APPEAL SUMMARY

Appeal ID: 18772	Project Address: 3714 SW Macadam Ave
Hearing Date: 12/19/18	Appellant Name: Jeancarlo Saenz
Case No.: B-007	Appellant Phone: 9727269400
Appeal Type: Building	Plans Examiner/Inspector: Maureen McCafferty, Joe Thornton
Project Type: commercial	Stories: 8 Occupancy: R-2, M, S-2, A-3 Construction Type: Type I-A & Type III-A
Building/Business Name: E2 - Block 40	Fire Sprinklers: Yes - Thoroughout
Appeal Involves: Erection of a new structure	LUR or Permit Application No.: 17-110666-LU
Plan Submitted Option: pdf [File 1] [File 2]	Proposed use: Mix-use building

APPEAL DECISION

A1.1
SITE PLAN

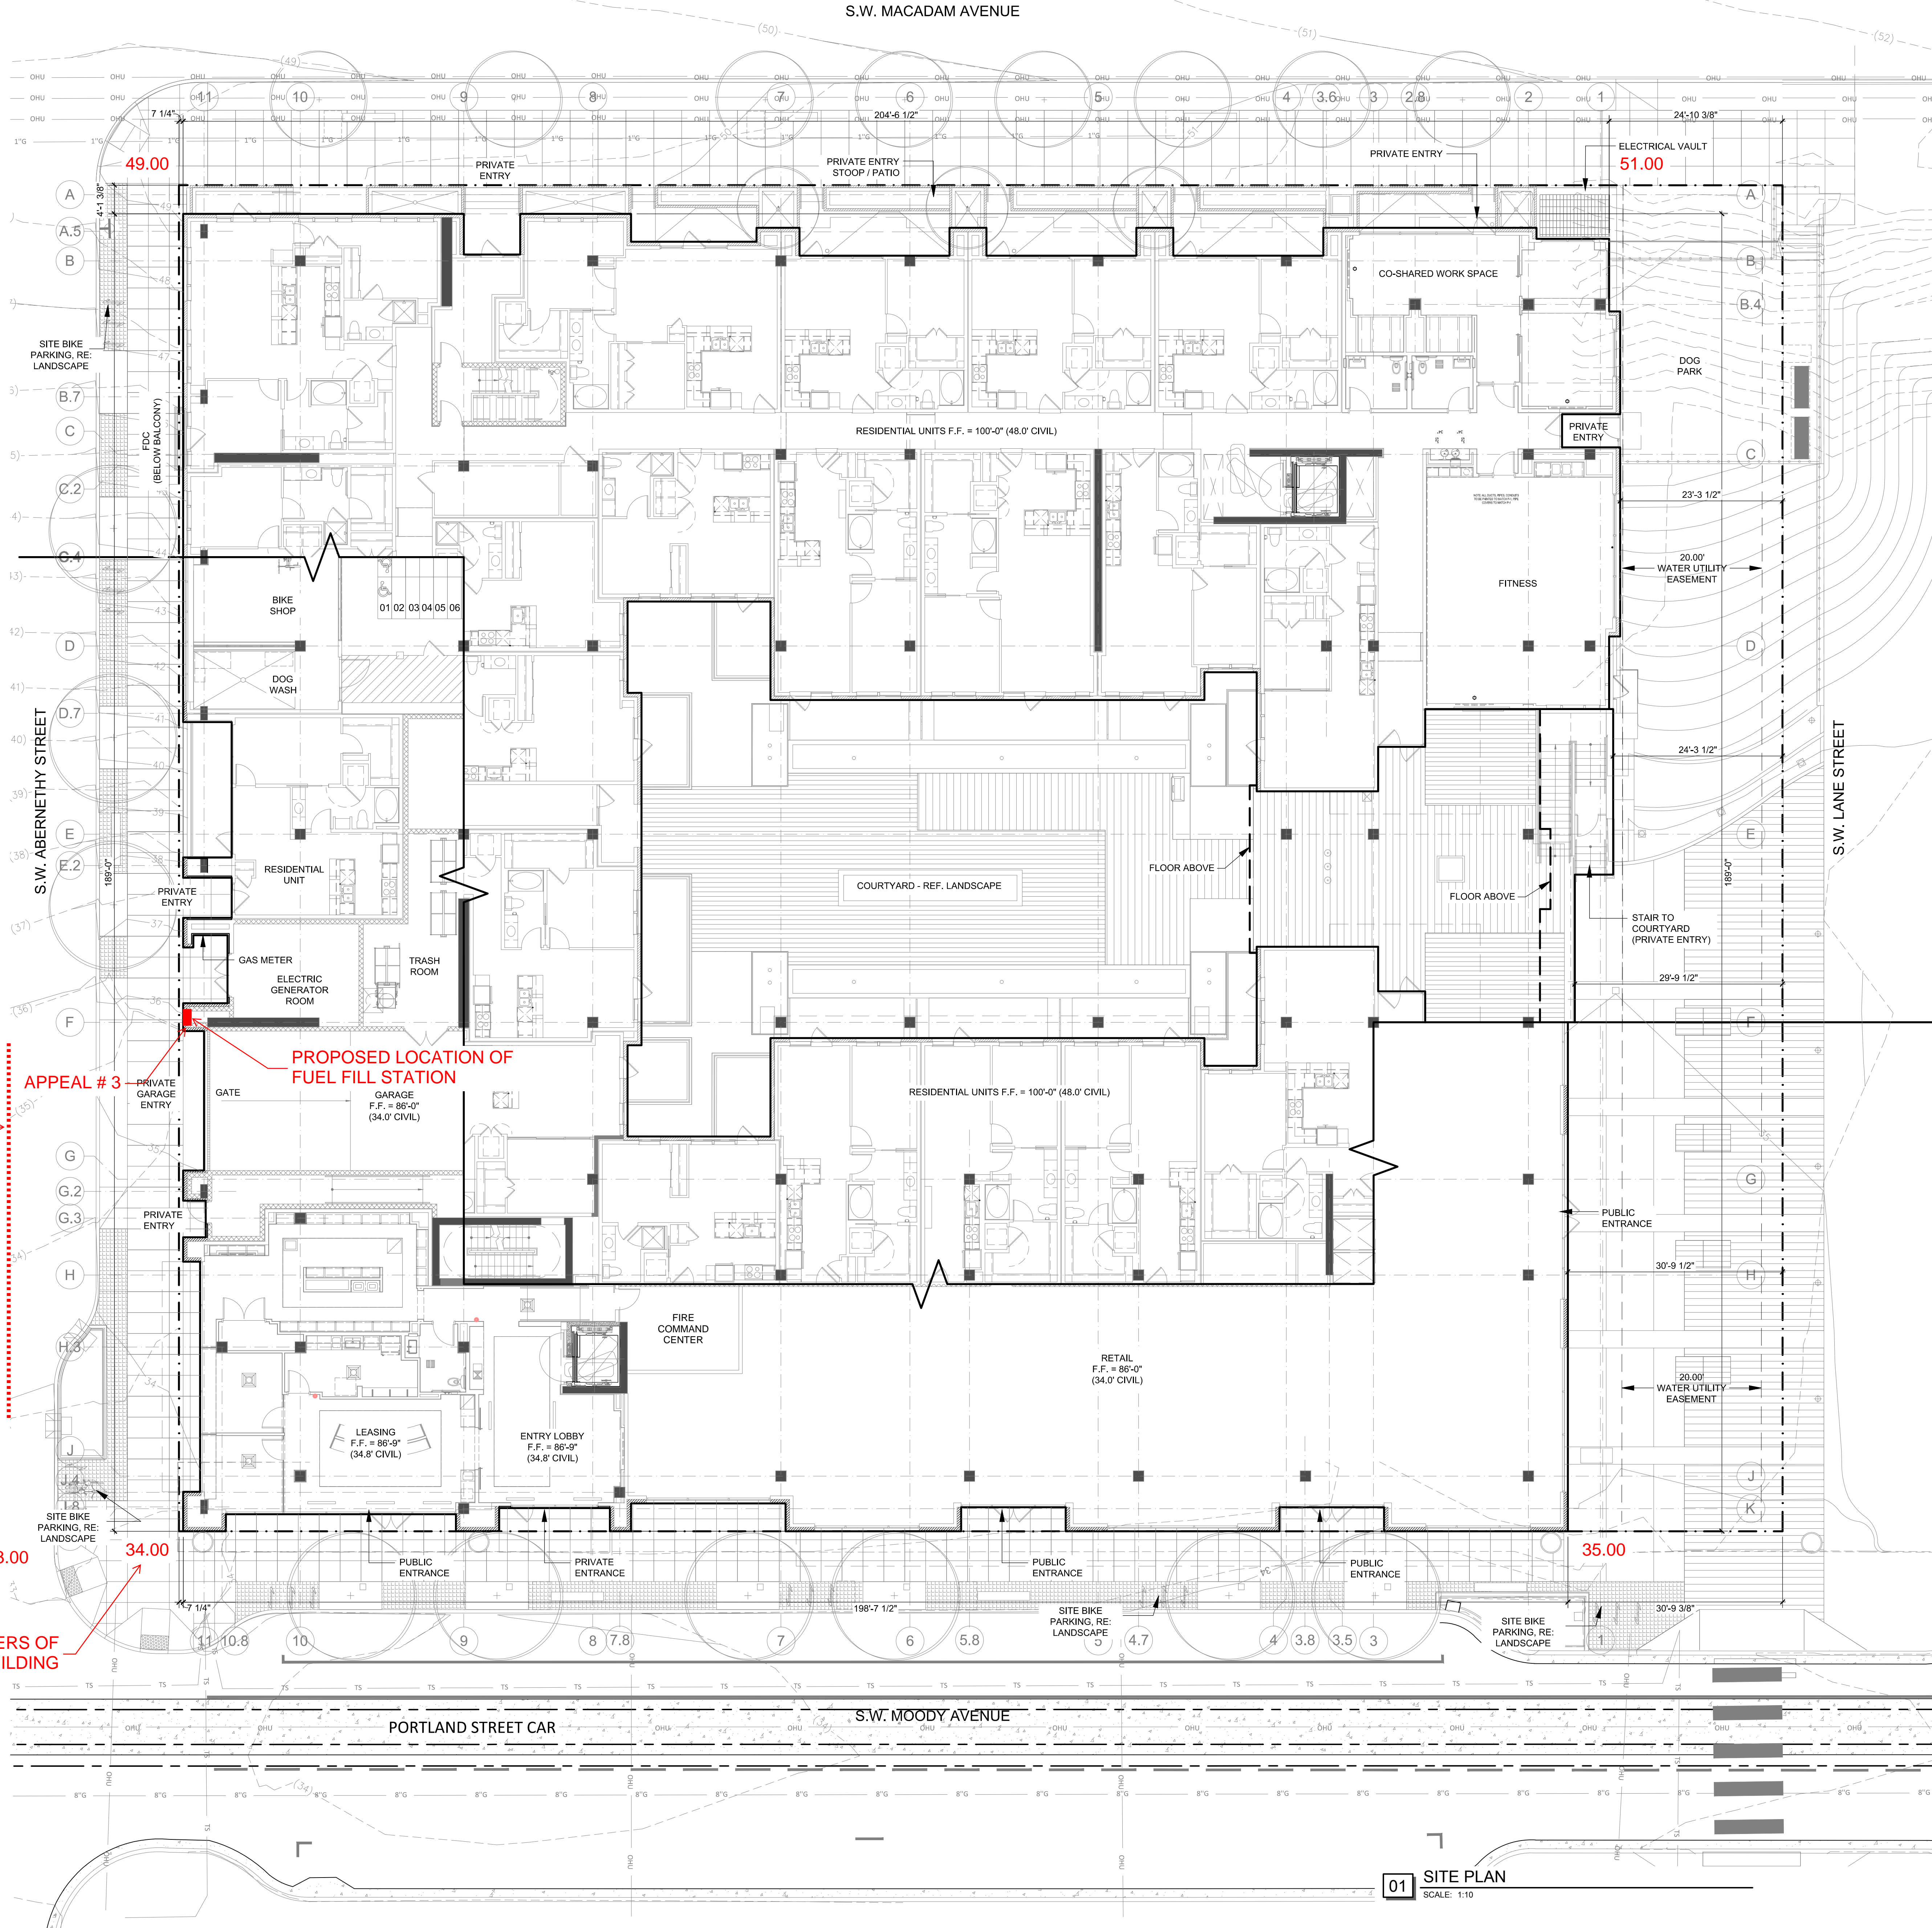
Proposed Design The proposed building is an 8-story (5 over 3) apartment building that has an occupied floor at 79' -8 ¾" from the lowest level of fire department access. For this reason, this building follows under the classification of high-rise per section 403 of the 2014 OSSC. For the design of this high-rise, we proposed the following conditions:

Reason for alternative The proposed changes to the high-rise code are in response to the unique conditions of this building. Site grading plays a good roll in the classification of this building as a high-rise since the site drops 17 feet from SW Macadam to SW Moody, which raises to highest occupied floor level above the 75 feet high-rise code threshold.

The current configuration exceeds the max height by 4'-8 ¾" on the top floor of the building, which in our opinion does not introduce a higher risk on smoke control or evacuation times for the following reasons:

- Due to the limited height above 75ft and grade conditions, the stack effects risk is not greater than it would be in a non-high-rise building. If the site was flat, the added height above the 75 ft line could be reduced by adjusting the ground floor, which means that all the stories above will still be the same. Shafts and enclosures would functions in the same way and should serve the same amount of stories.

6. Partial omission of high rise requirements: Denied. Proposal does not provide equivalent Life Safety protection. Appellant may contact John Butler (503 823-7339) with questions.

A0.3K

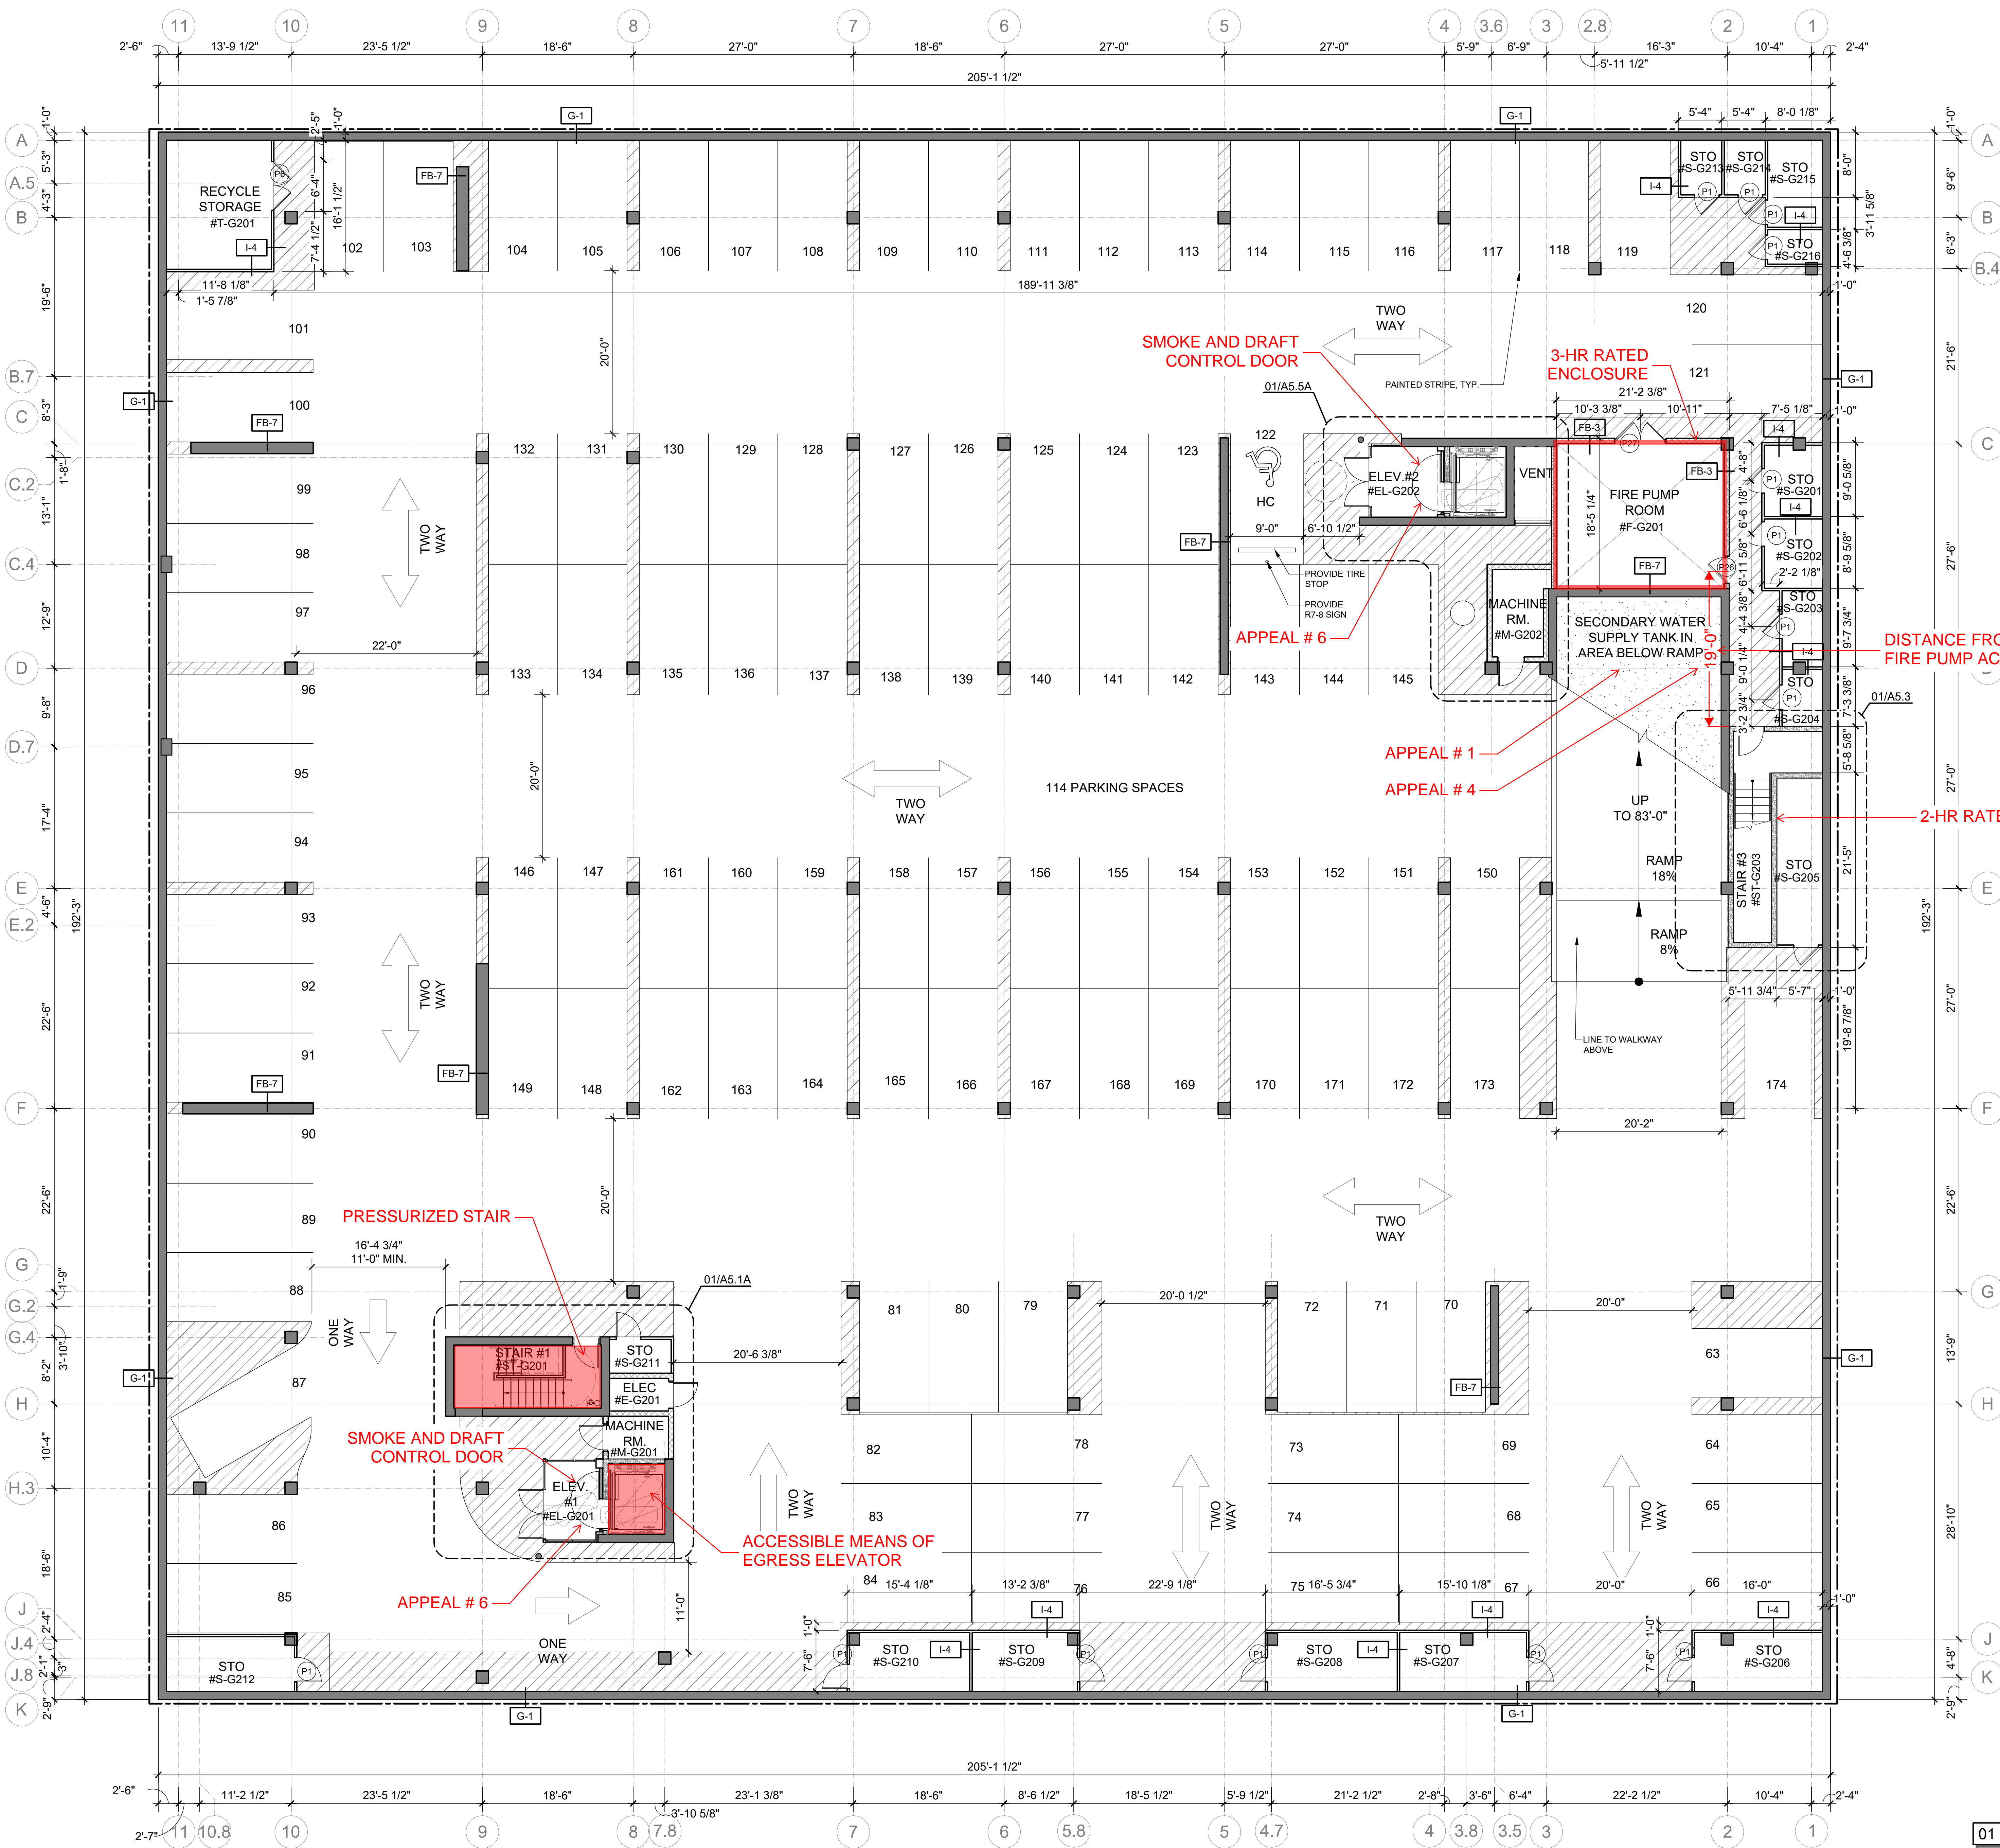
Proposed Design The proposed design is an 8-story mixed-use high-rise multi-family building, with 5 levels of Type III-A construction over 3 level of Type I-A construction at grade. There is 1 level of below-grade parking, also of Type I-A construction. The building will be equipped throughout with an automatic sprinkler system. The fire pump room is located at Garage level 2, at the northwest corner of the parking garage.

The proposed design does not provide a continuous rated direct connection to an interior exit stairway.

The fire pump room enclosure is 3-hour rated, and the nearest exit stair enclosure is 2-hour rated. The path of travel between the fire pump room and the enclosed exit stairway measures 18 feet in length and is sprinklered per NFPA 13. The path is unenclosed and is along a corridor in the garage that is isolated from car traffic.

Reason for alternative The fire pump room will be provided with more protection than required by code. Since the building is sprinklered and a high-rise, the pump room is only required to be 2-hour rated, but the proposed design provides a 3-hour pump room enclosure. Access from the pump room to the exterior is through a 2-hour rated stair enclosure, and the path of travel between the stair and the pump room is direct and clearly visible. This path is within the Type I-A concrete parking garage, and measures 18 feet from door to door. Clear signage will be provided at the pump room and the stair enclosure. We believe the proposed design provides equivalent level of life safety as is required by code.

3. Omission of 2 hour fire rated passageway connecting fire pump room to exit: Granted as proposed.
